2212 WEST 10TH AVENUE
VANCOUVER, BC

SHADOW ANALYSIS: JUNE 21 (PDT: UTC-7:00) LOE SUBMISSION: 14 STOREY TOWER ON 6 STOREY PODIUM-20 STOREYS

Please find below the details for a new rezoning application under the Broadway Plan for a site located at 2212 West 10th Ave. Posse file number: RZ-2024-00090

SHADOW ANALYSIS: MARCH 21 (PDT: UTC-7:00)

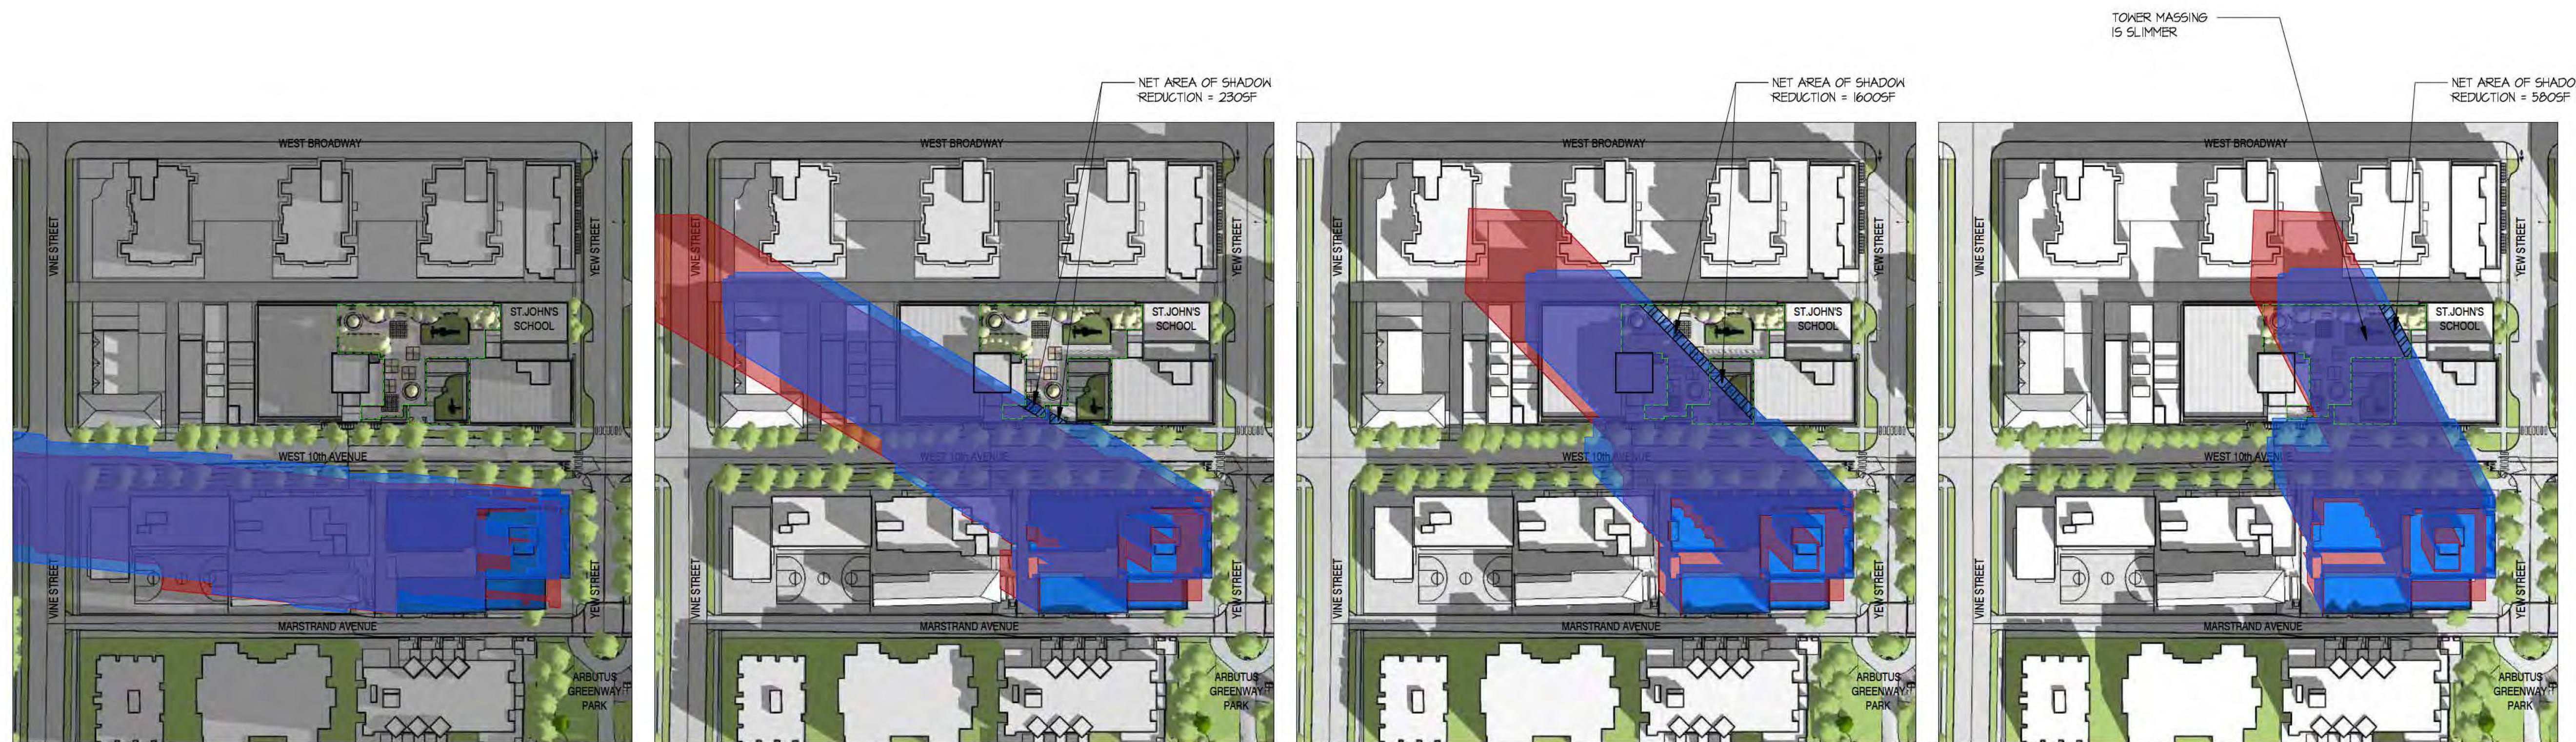
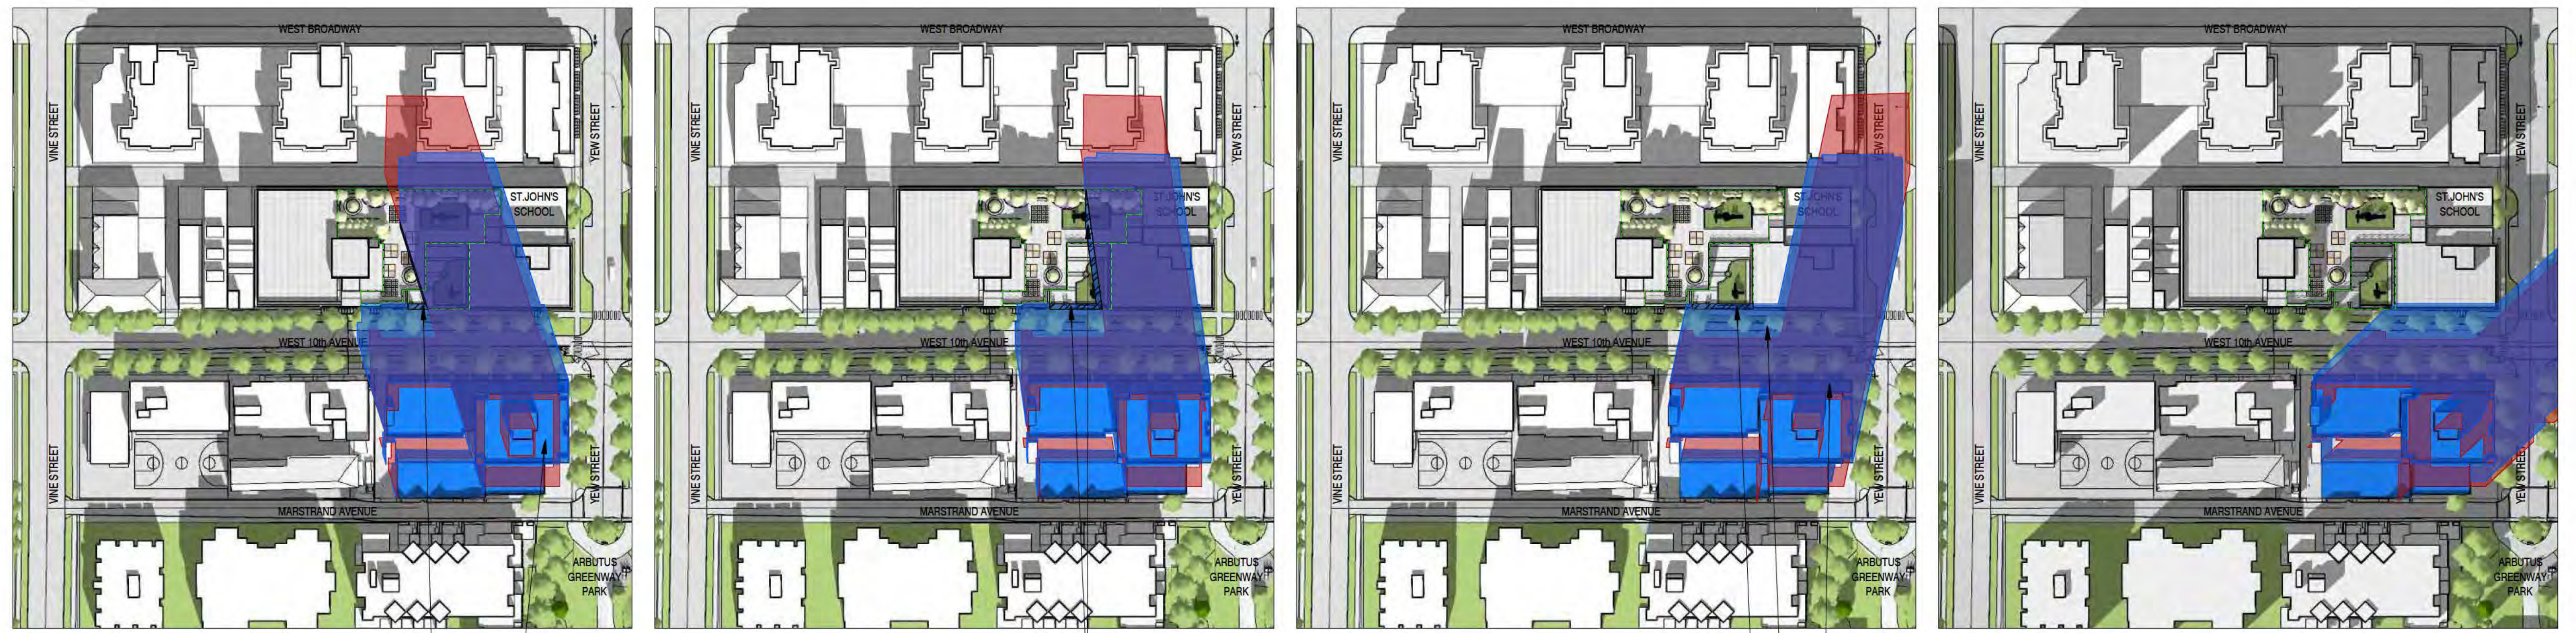
Staff recommend that overlaid shadow analysis clearly quantify the net area of shadow reduction from Rezoning Enquiry submission to Rezoning Application submission onto the St John's School (SJS) yards and playgrounds.

Shape of the City owned Lane prior to the redevelopment of CD-1 341 lands:

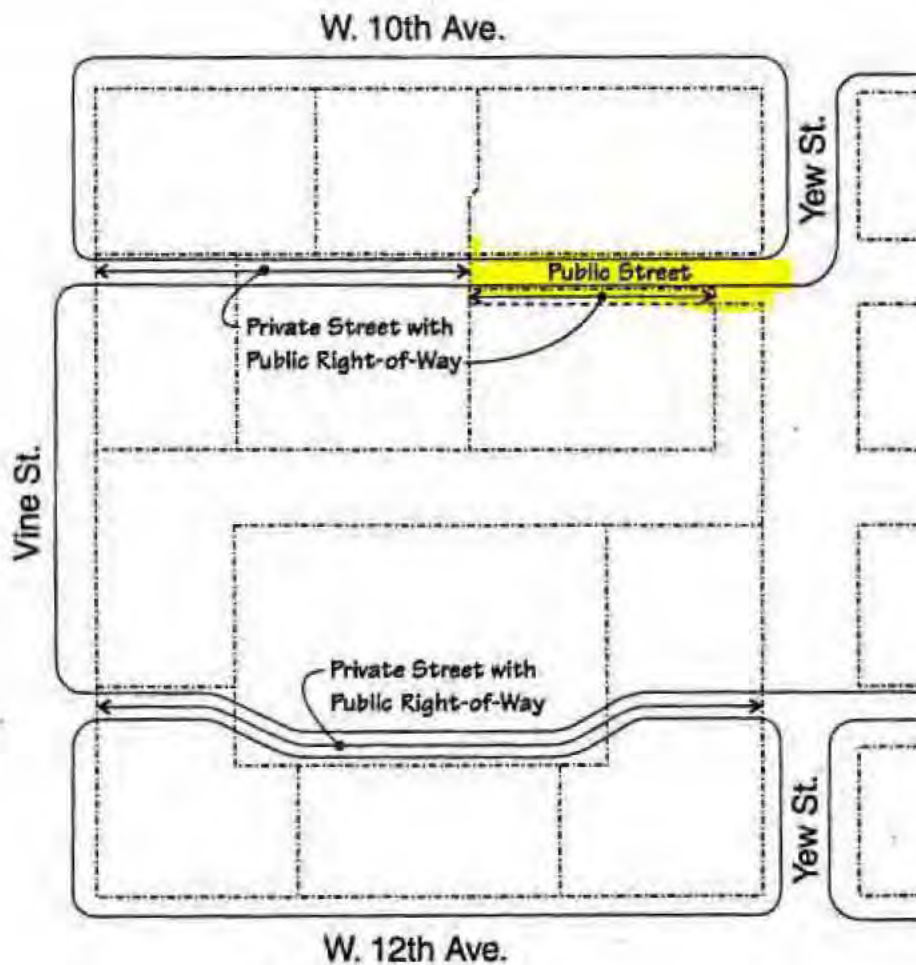
Further to that, the portion of Marstrand Avenue west of the Telus site is part of the CD-1 and is privately owned land that has a public right-of-way placed on it to allow public access. Marstrand avenue was historically a lane, but with the redevelopment of the CD-1 area, the Private lane was granted a Street name to allow developments to front on Marstrand. As it is narrower than a normal City-owned street, our Streets team considers the public portion a lane.

Should the City treat Marstrand as the front property line for the Telus development, there would still be no setback sought, as C-7 does not have a required front yard.
